SSDA RESPONSE TO SUBMISSIONS REPORT

MELROSE PARK SOUTH – EAST – BLOCK 05

REPORT PREPARED BY FK ON BEHALF OF WHARF AND HUGHES DEVELOPMENTS PTY LTD

JAN 2026

DA-E-B5-AR-500 COMPLIANCE - GFA
 (REFER ALSO DA-E-B5-AR-501 AFFORDABLE HOUSING ALLOCATION)

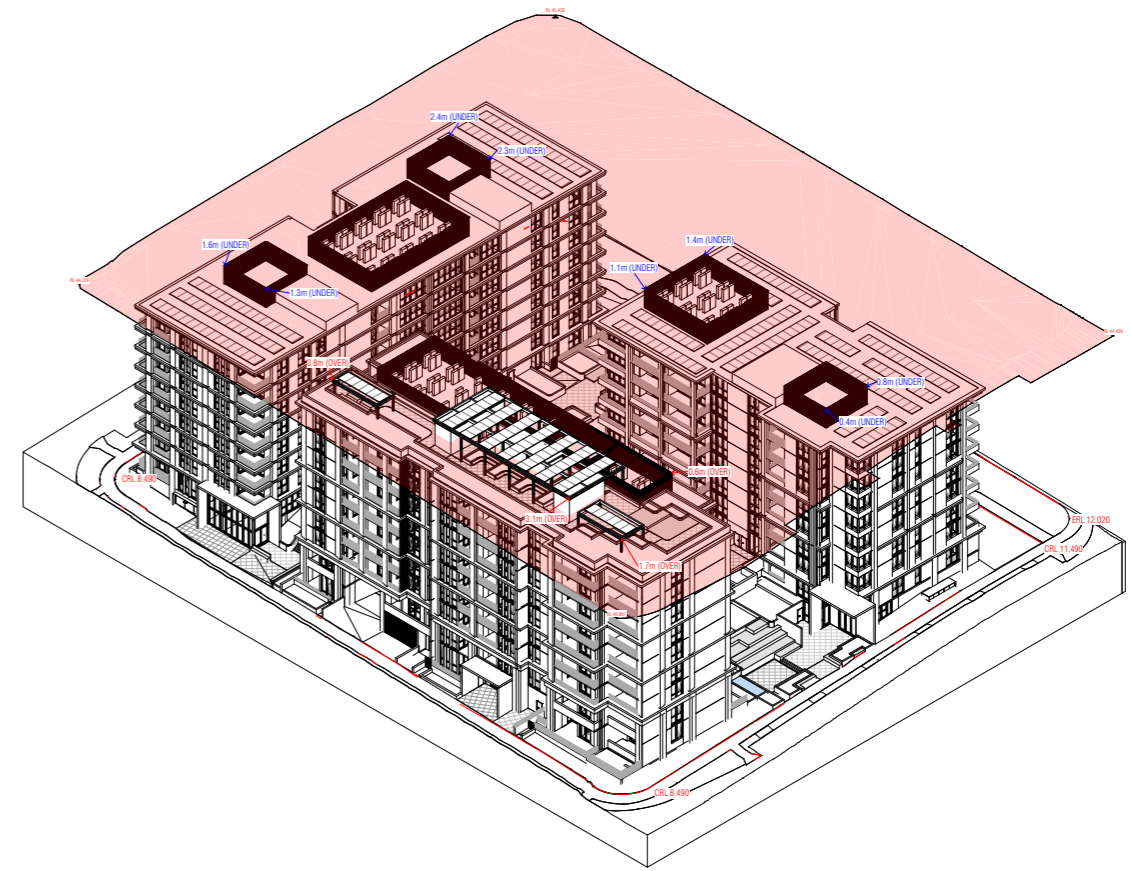
- The amount of affordable housing GFA provided under the Housing SEPP is only 14.17%. This must be increased to a minimum of 15%, excluding the affordable housing GFA to be delivered under the Voluntary Planning Agreement (VPA). Provide revised plans and calculations confirming a minimum 15% affordable housing GFA is achieved. Note any change to the Housing SEPP affordable housing numbers will require an updated letter of agreement from the Community Housing Provider and updated car parking calculations.

- Please review the GFA and affordable housing GFA calculations in relation to:
 - the architectural floorplans for Block B5 indicate GFA on basement levels 1 and 2 that are not included in the GFA calculations on drawing DA-E-B5-AR-500

- drawing DA-E-B5-AR-500 indicates the GFA of lobbies and corridors that also serve market apartments (up to level 1) have been allocated entirely as affordable housing GFA.

- An additional 2-bedroom affordable housing unit has been incorporated on Level 06. Architectural plans have been updated confirming the revised affordable housing GFA and allocation, which now achieve a minimum of 15% affordable housing GFA in accordance with the Housing SEPP requirements across the Eastern Precinct.

- The lift lobbies shown on Basement Levels 01 and 02 in the architectural floor plans have been removed and are not included in the GFA calculations. Please refer to the corresponding basement floor plans for clarification.

- The GFA associated with lobbies and corridors is allocated to affordable housing only where the relevant building level is fully occupied by affordable housing dwellings (whether delivered under the Housing SEPP or the VPA). Where these common areas also serve market apartments, the GFA has not been attributed to affordable housing. Drawings DA-E-B5-AR-500 and DA-E-B5-AR-501 provide the updated GFA breakdown and allocation.

DA-E-B5-AR-512 HEIGHT PLANE DIAGRAM

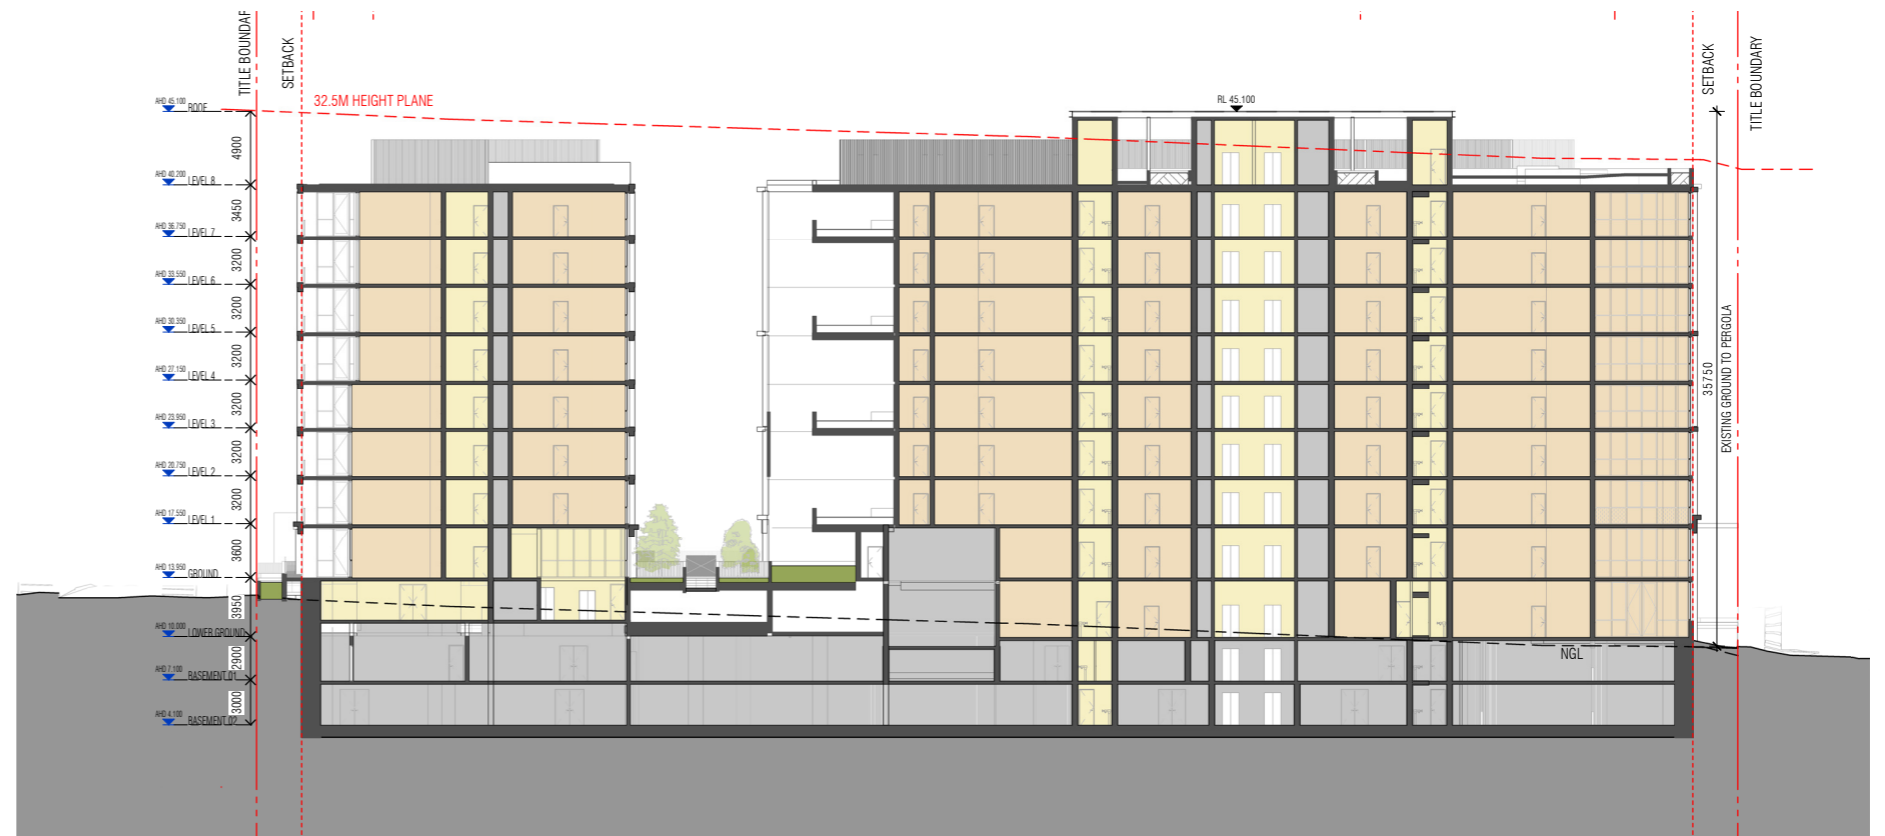
- The Department raises concern that the proposed roof top structure on Block B5 does not satisfy the provisions of clause 5.6(3) of the Parramatta Local Environmental Plan 2023 and therefore does not constitute an architectural roof feature. The Department also raises concern in relation to the design integration, scale and shadow impacts of this structure element and recommends it be redesigned, reduced in scale or eliminated from the proposal.
- Should any structure be retained above the building height control, you will need to provide a long section indicating the proposed height, as well as a clause 4.6 variation request.
- Provide a 3D image of the height plane for Block B5 (as per drawing SSDA 508 for Block B4).
- Ensure elevations and sections include the existing ground line and existing and proposed RLs.

- We acknowledge the Department's concerns regarding the rooftop structure on Block B5 and its compliance with Clause 5.6(3) of the Parramatta Local Environmental Plan 2023. The proposal reduces the extent of roofing to reduced and setback from the parapet edge to reduce the bulk and scale presented to the street
- As the structure exceeds the building height control, a Clause 4.6 variation request will be prepared to address the non-compliance and to demonstrate that the proposal achieves an appropriate planning outcome notwithstanding the numerical breach.
- Refer DA-E-B5-AR-252 illustrating the proposed height of the rooftop structure relative to the height control has also been provided in support of the variation request.

DA-E-B5-AR-502 COMPLIANCE - SOLAR

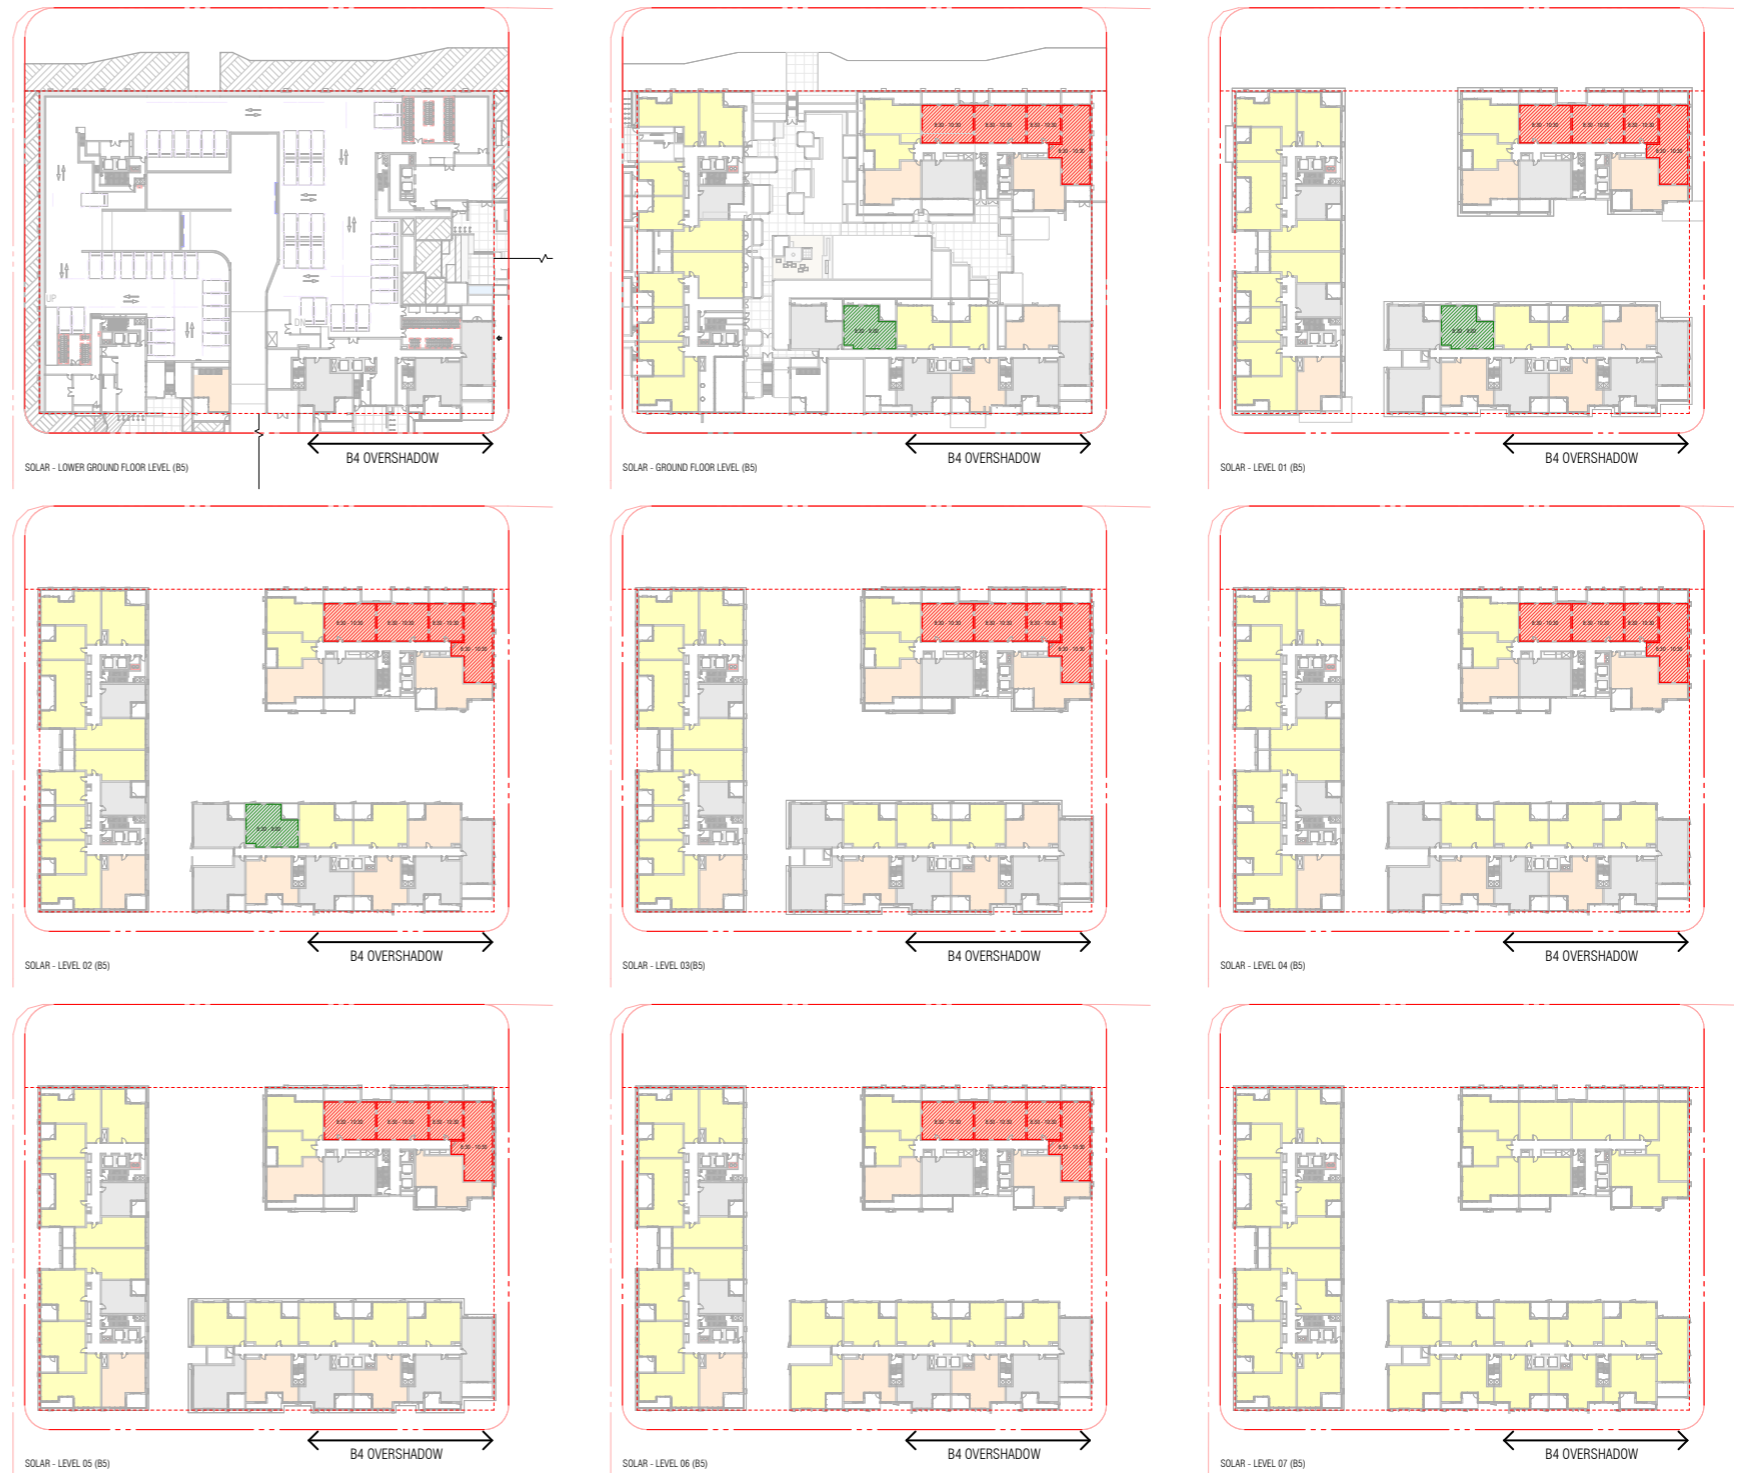
- Solar access performance across each block and the overall development does not meet the Apartment Design Guide (ADG) solar access recommendations. The Department notes 70% solar access in midwinter is still not achieved across the development, even with consideration of an additional hour in midwinter (8.30 am to 3.30 pm). You are therefore requested to:
 - Further investigate the design to achieve an improved solar access outcome
 - Confirm the design measures undertaken to maximise solar access within each block to living areas/private open space and to communal open space.

While the proposal does not fully achieve the ADG's 70% mid-winter solar access benchmark, the design reflects the maximum feasible outcome given site orientation, and surrounding context.

FK have incorporated multiple strategies to improve solar access, including optimised building orientation, prioritisation of northern/eastern aspects for living areas, and refined massing and courtyards to increase sunlight to apartments and communal spaces.

Earlier schemes included stepped building forms that improved solar access; however, these were removed following DRP to achieve a calmer built form more fitting with the precinct.

Further precinct development from the Design Review Panel's feedback led to adopting the proposed block form. This allowed for greater solar access to B6, which in turn reduced B5's overall performance, prioritising precinctual amenity. (this testing can be seen in the B6 report on solar)

Although full ADG compliance metric has not been achieved, the design intent of optimising residential amenity through solar access has been met. (see section ADG Apartment amenity)

DA-E-B5-AR-504 COMPLIANCE - C.O.S

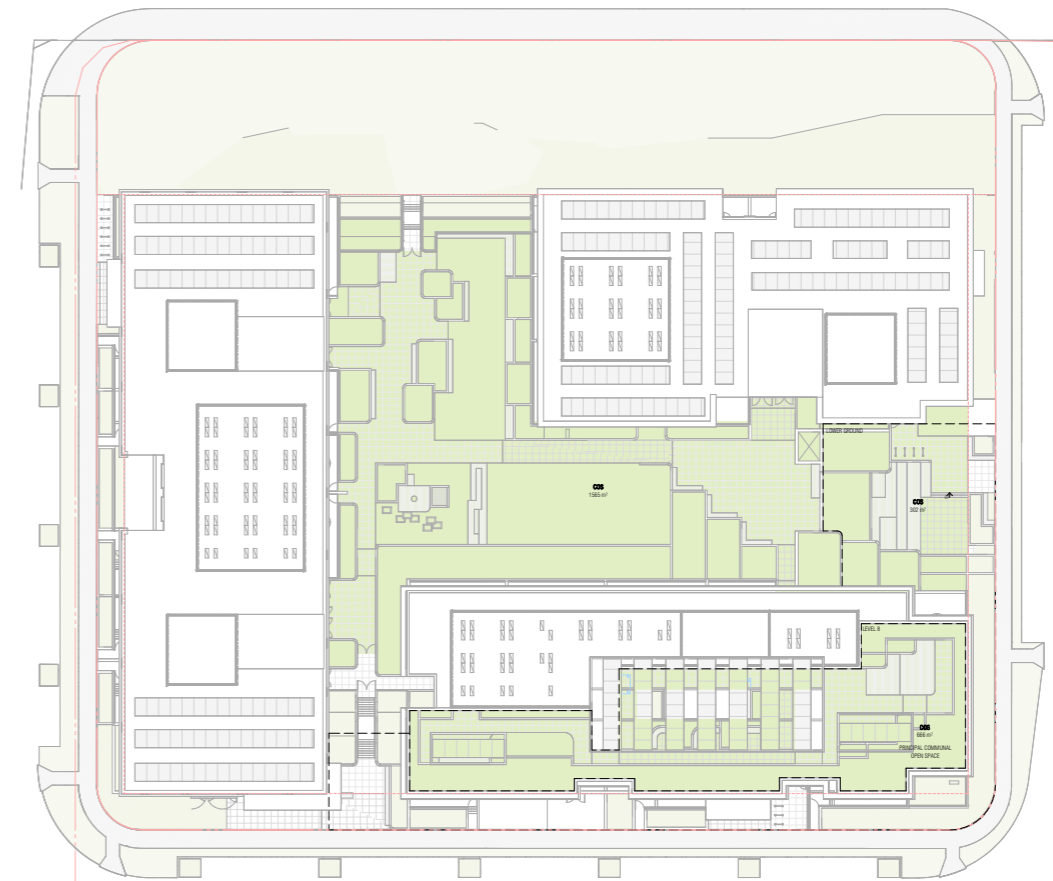
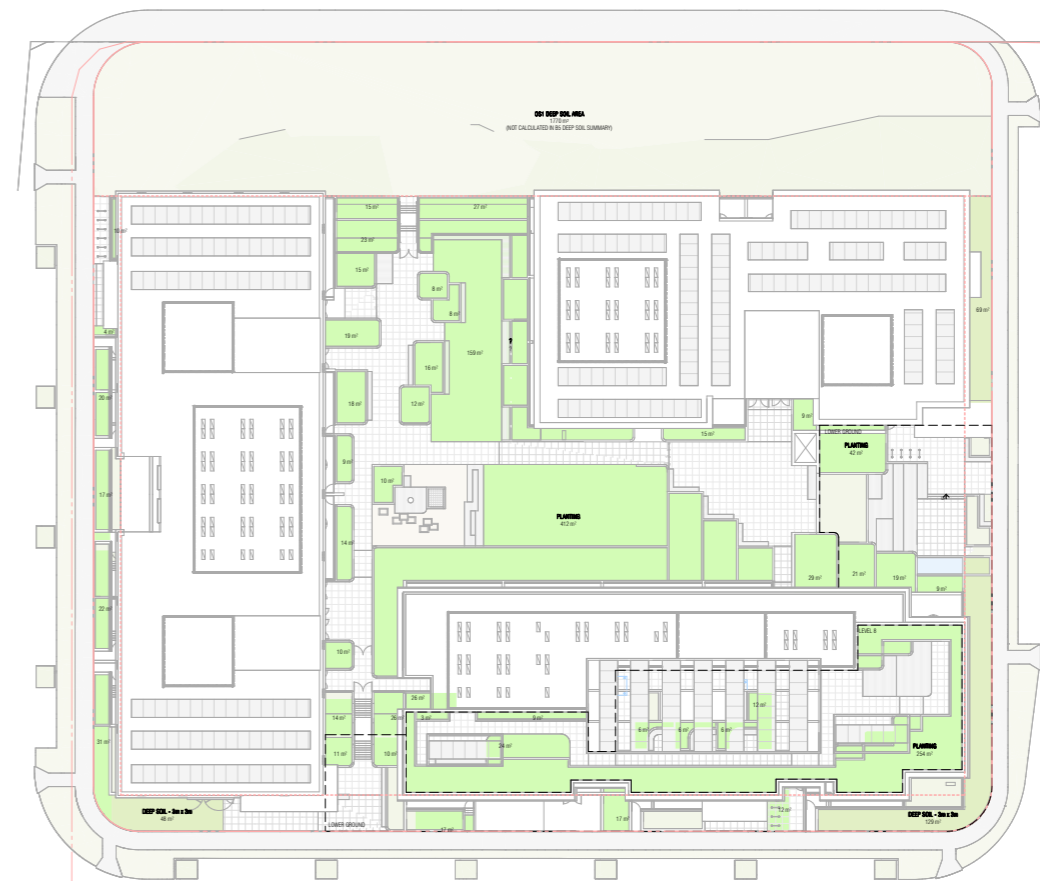
- Provide a table confirming deep soil zones (with a minimum dimension of 6 m and separately, between 3 m and 6 m) and landscaped areas within each block, the overall developable area of the site and the overall site.
- Confirm rooftop communal open space areas would be available to residents of each building within the respective block.

- Table which indicates deep soil zones (with a minimum dimension of 6 m and separately, between 3 m and 6 m) and landscaped areas within B5 has been provided, please refer to DA-E-B5-AR-504 and DA-E-B5-AR-505.
- Rooftop communal open space areas would be available to residents of each building within B5.
- Refer planner's report for justification of deep soil allocation having been part of the Open Space offering provided as part of the SSDA

DA-E-B5-AR-099 LOWER GROUND FLOOR PLAN

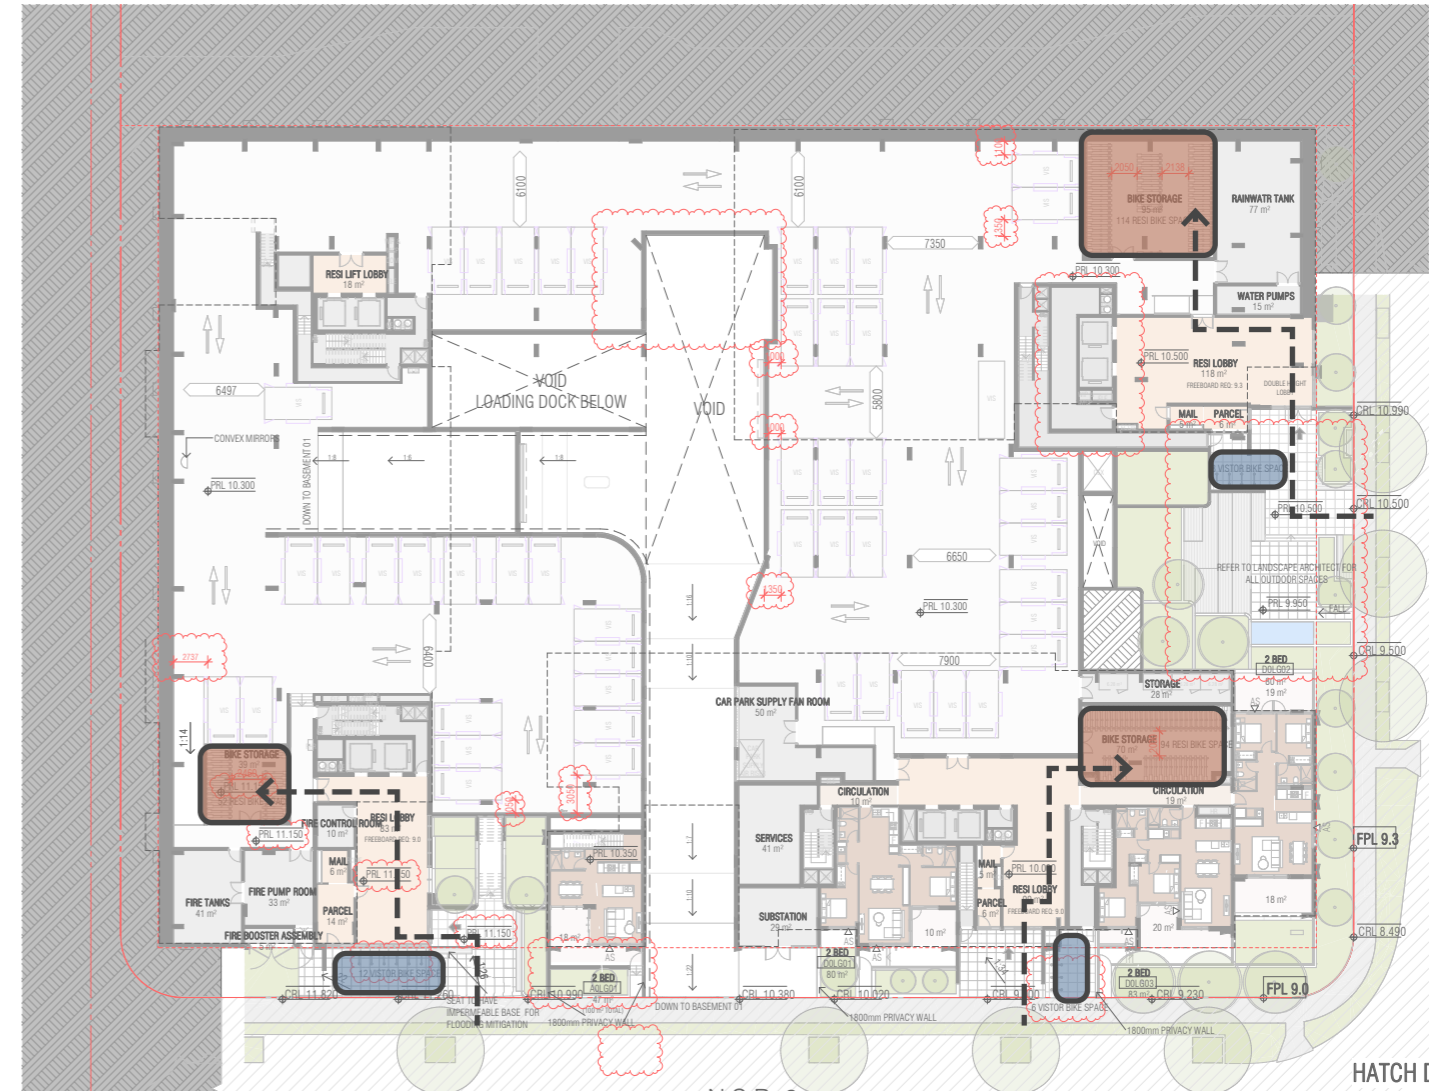
- Review the location of residential visitor bicycle parking spaces to ensure they are located as close to ground level as possible within each block.

- For all 3 Blocks, the incline of bicycle parking egress ramp(s) must not exceed 8% for a ramp length of up to 20m or 7% for a ramp length of up to 40m as per Austroads Guide to Road Design Part 6A: Pedestrian and Cyclist Paths, Figure 7.1: Desirable uphill gradients for ease of cycling, to encourage use by slower, less confident 15 percentile recreational bicycle riders per Cycling Aspects of Austroads Guides, Figure 4.1: Bicycle operating speeds.
- To encourage active transport, Council recommends that all bicycle parking facilities (across all blocks) be provided at basement level 1 for ease of access.

- Location of residential visitor bicycle parking spaces are located at the lobby entries external to the basements. Please refer to DA-E-B5-AR-099 and DA-E-B5-AR-100. This is consistent with Council's recommendation to provide convenient access that supports and encourages active transport.
- No access will be granted to cyclists via the traffic ramp. The client has confirmed all access to the basements shall be via the lobbies/lifts. Where possible residential bicycle parking is on the lower ground basement and localized near lifting/lobbies
